DETAIL AT PERIMETER COLUMNS

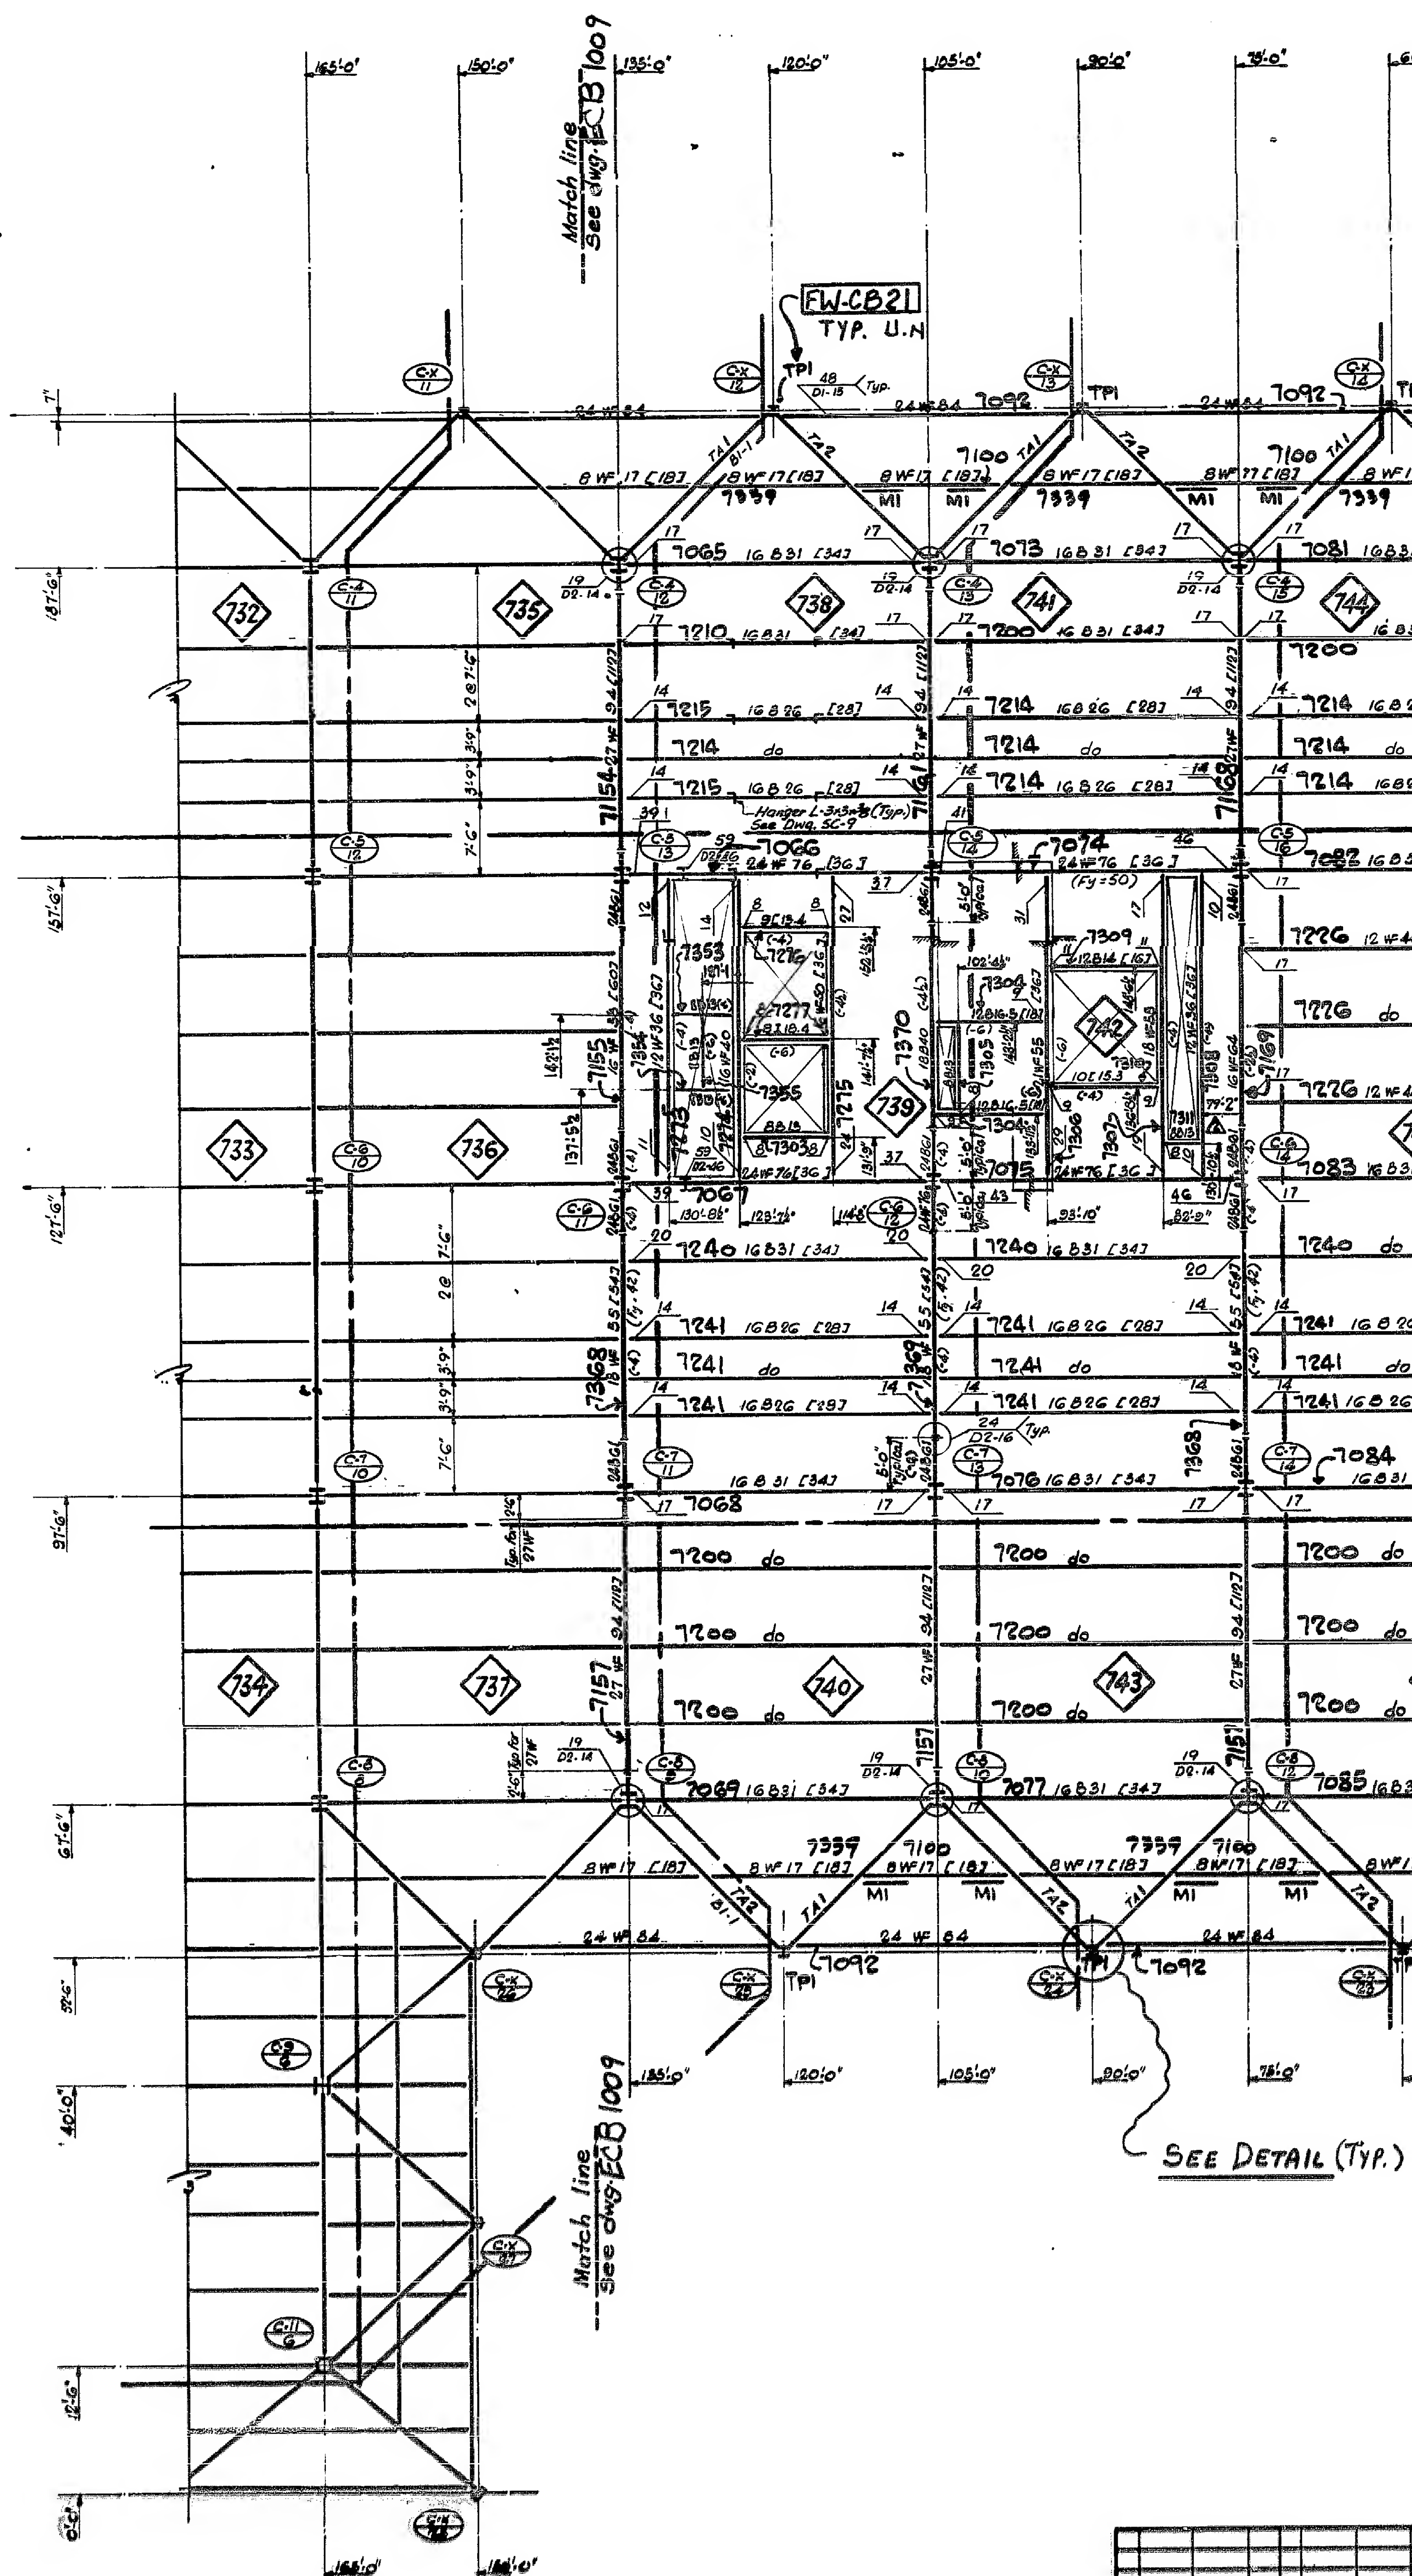
{ 349'-6³ THEO. ELEV.
349'-6² ERECTED ELEV.

ADJUST SHIMS @ BOTTOM
CHORD @ DEEP END OF TRUSS
TO ACHIEVE ERECTED ELEV.
